Project Name: 105 NE 7th Street (2020-241)

Request: Certificate of Appropriateness

HISTORIC PRESERVATION BOARD STAFF REPORT

105 NE 7th Street

SHEET
A02

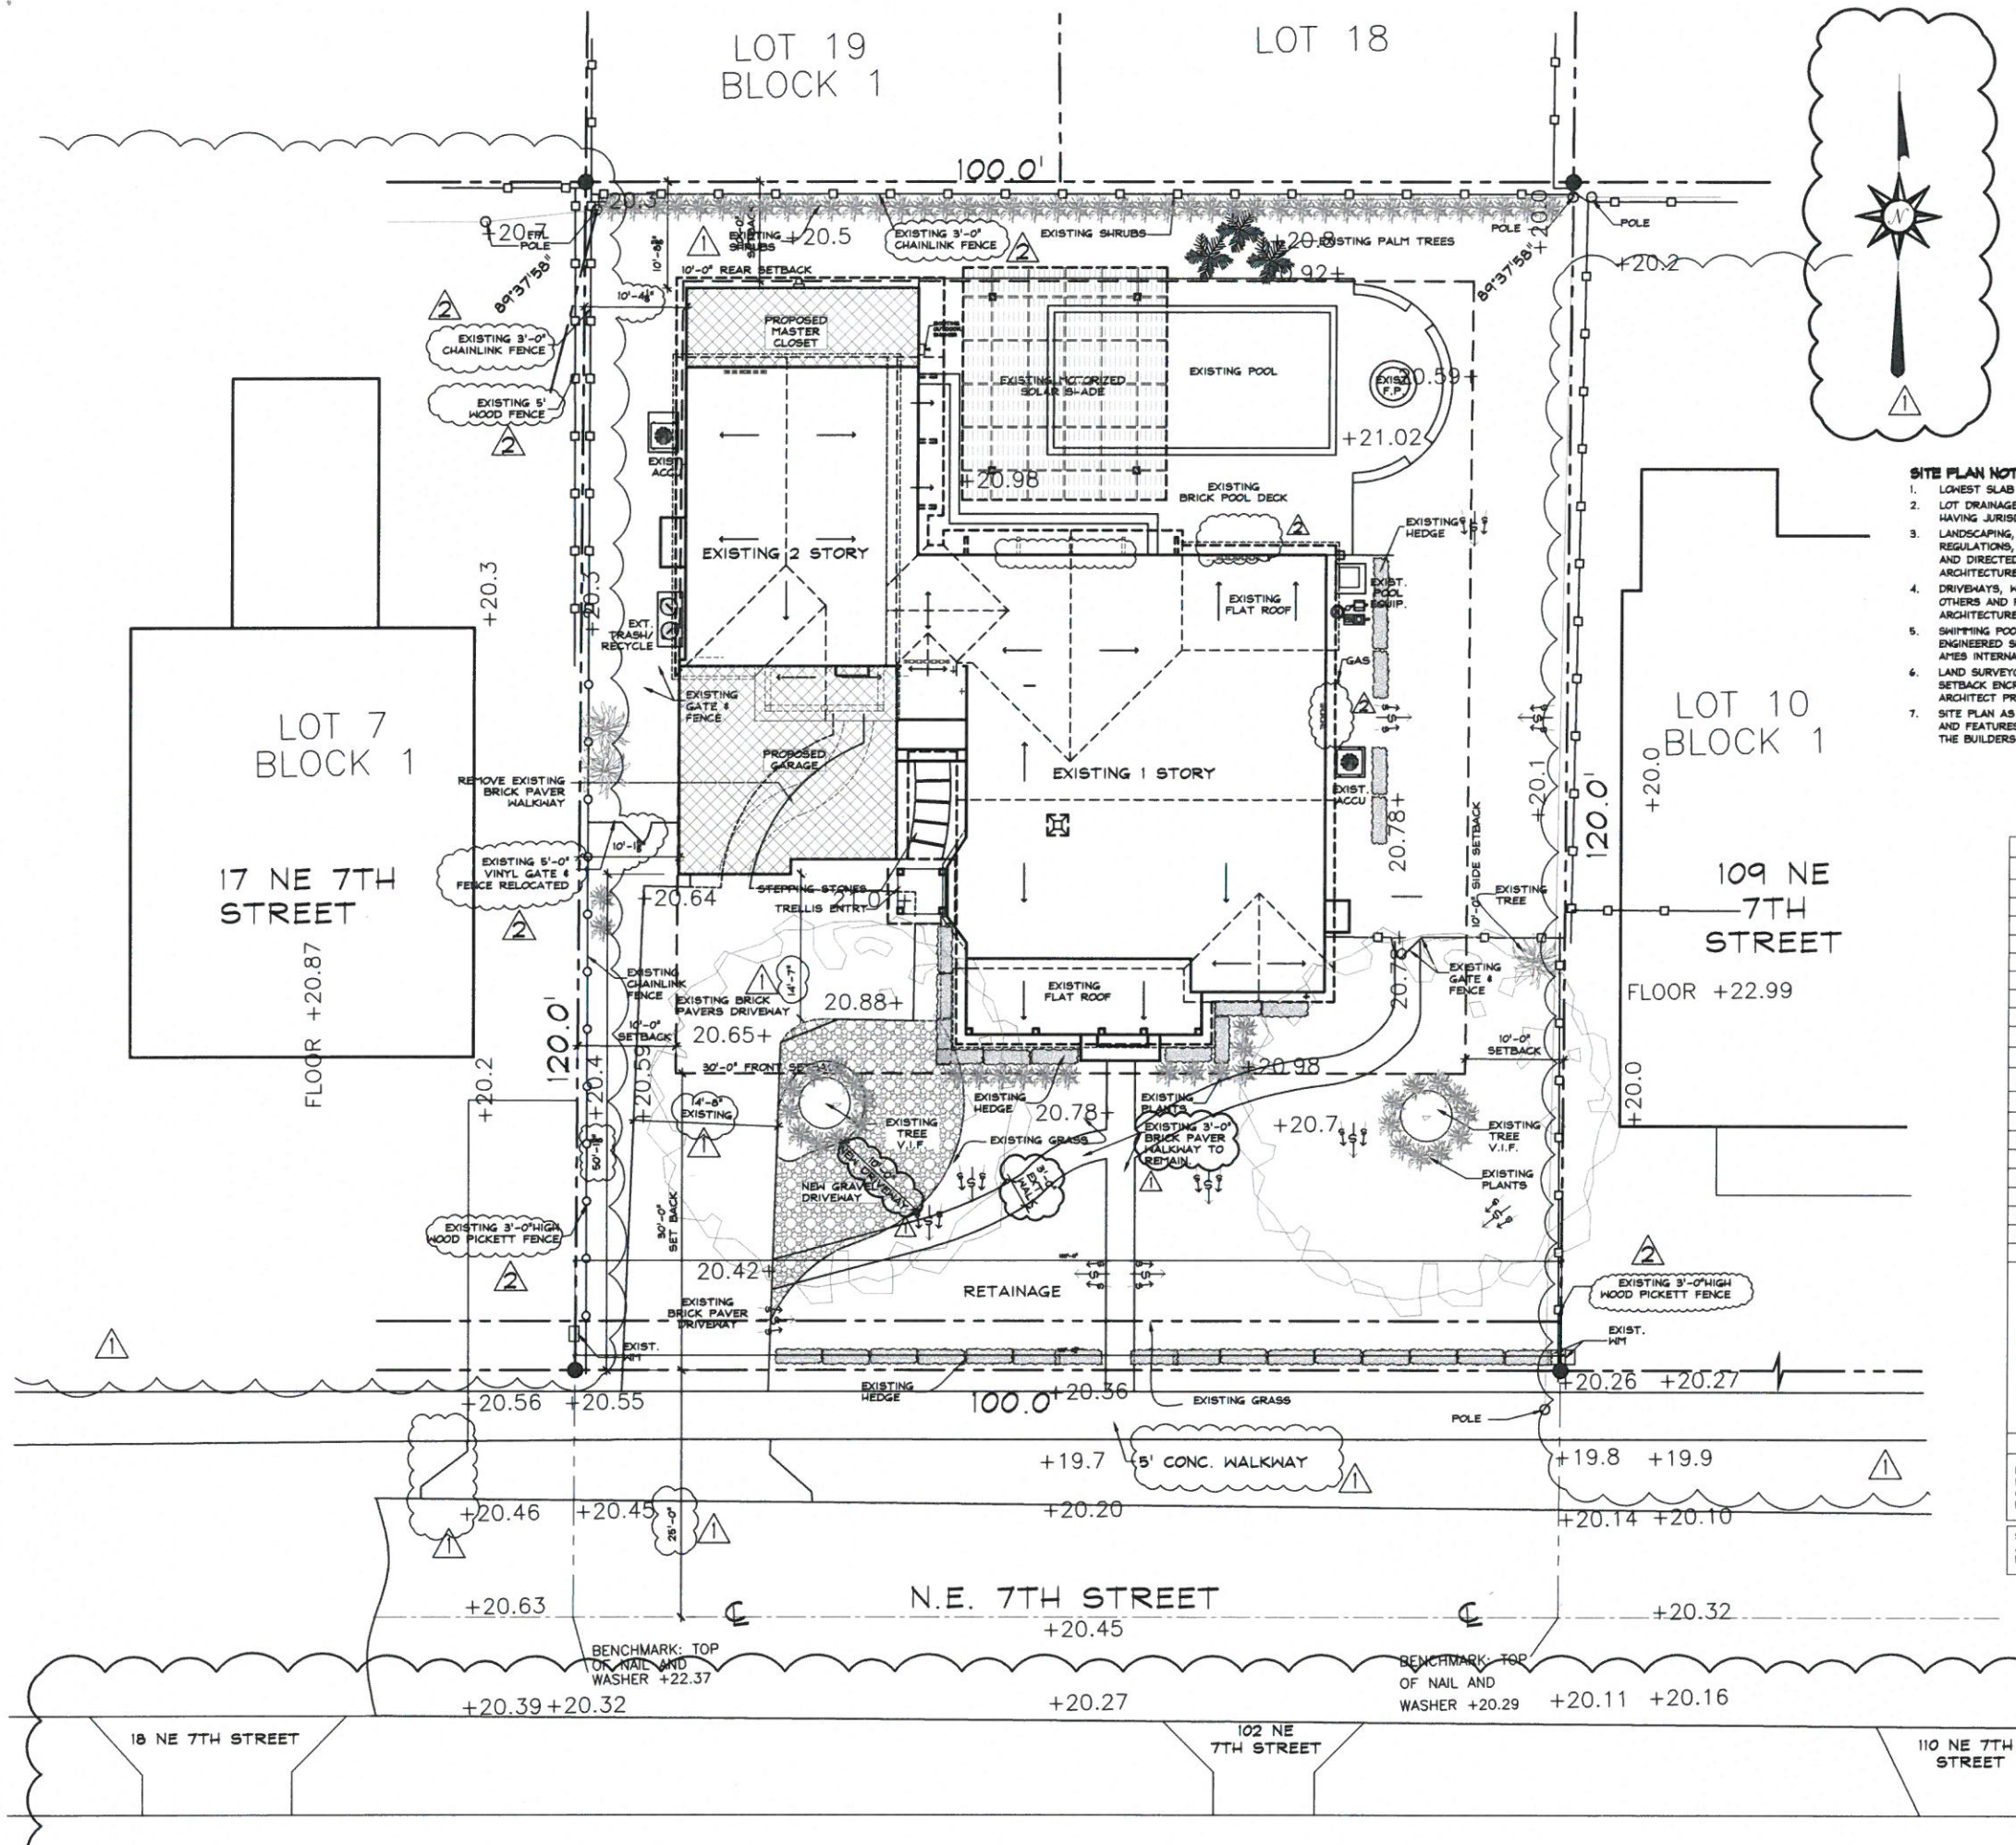
1. That the site plan be revised to match the scale of the survey, which is 1"-10'.
 2. That setbacks for all existing structures be added to the site data table and illustrated on the site plan.

3. That the existing wood picket fence on the south property line be illustrated on the site plan.
 4. That the proposed setbacks for the garage and master closet addition be included on the site data table and illustrated on the site plan.
